**FRONT AXLE**

**DRIVE SHAFTS**

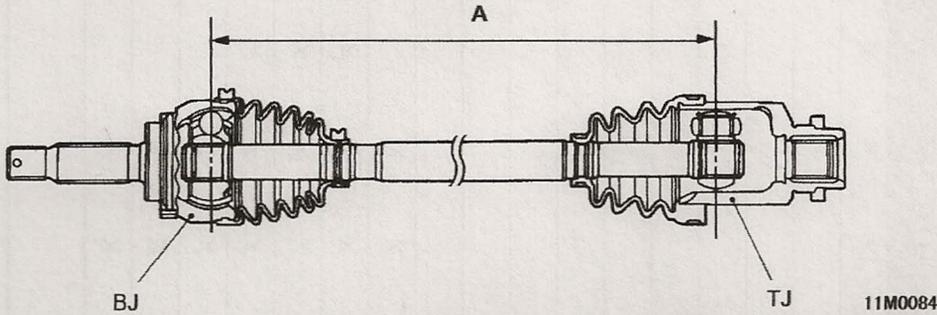
The joint-to-joint distance of the drive shaft (dimension A in the illustration) has been revised.

Item		EVOLUTION-VI	Base vehicle (EVOLUTION-V)
Joint-to-joint distance (dimension A) mm	LH side	352	365
	RH side	429	442
